**City of Bellevue
Development Services Department
Land Use Staff Report**

Proposal Name: Serena Short Plat

File Number: 13-111863-LN

Decisions Included: Preliminary Short Plat (Process II)

Figure 1 – Preliminary Short Plat Proposal

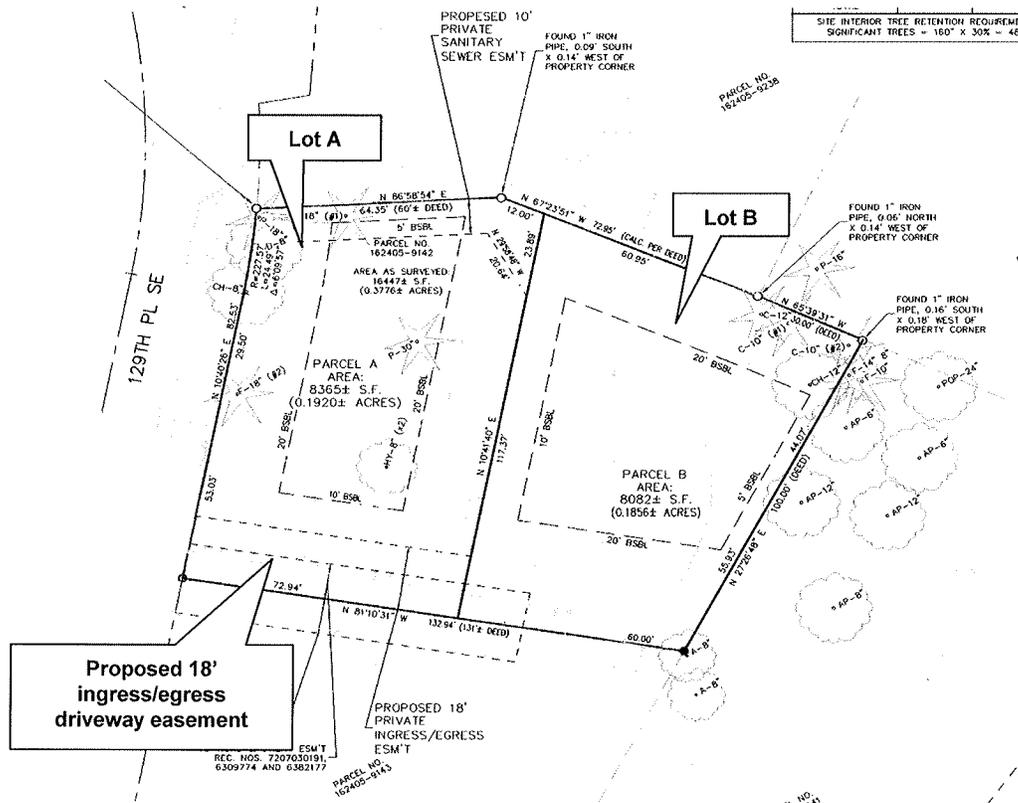
The applicant is proposing to short plat an existing 16,447 square foot lot (approximately 0.37 acres) into two (2) single-family lots. The subject site is located with the R-5 land use district, and within the Factoria subarea. The site contains an existing single-family dwelling which will be demolished as a result of this short plat proposal. Access to the two proposed lots will be from a proposed ingress/egress driveway easement, which will run along the southern side of each lot, and accessed off 129th Place SE. Incorporation of the ingress/egress driveway easement will necessitate only one curb cut off 129th Place SE. The existing curb cut north of the proposed driveway will be removed.

As defined by Land Use Code 20.25H, the site does not contain any critical areas; however, the property currently contains eleven (11) significant trees consisting of Douglas Fir, Cedar, Cherry and Pines (160 diameter inches). The applicant proposes to retain four (4) of these trees, which equates to approximately 50% of the total diameter inches of the significant trees on the site.

Access to Lots A and B will be from a joint use driveway as shown on the approved plans. No other access connection to city right-of-way is authorized. The existing driveway which serves the existing house must be removed. Street frontage improvements matching adjacent improvements must be provided at the location of the removed portion of the existing driveway.

The driveway width will be a minimum of sixteen feet with Fire Department Approval and must be built per the City's Transportation Department Design Manual Standard Drawing DEV-7B.

Response: The applicant proposes to preserve a total of 50 diameter inches or 31% of the significant trees onsite. This satisfies the minimum 30% tree retention requirement. **Refer to project drawings attached to this report and Conditions of Approval regarding Tree Protection and Tree Retention in Section IX of this report.**

- a) Site Specific Items:
 - i) Driveway apron per DEV-7B.
 - ii) New channelization on 129th Place SE (fog line).
 - iii) Relocation of above grade utilities to accommodate new access location.
 - iv) New joint use driveway: 16 feet wide, paved full width, full length.

The City of Bellevue urges the applicant to save as many trees as possible. The final short plat shall portray a minimum of 50 diameter inches of existing significant trees to remain, as proposed. A Tree Preservation Plan that portrays the drip-line, the diameter size, and common name of each significant tree to be retained must be recorded with the *final short plat mylar* (recorded with King County). This Tree Preservation Plan must also contain the following note:
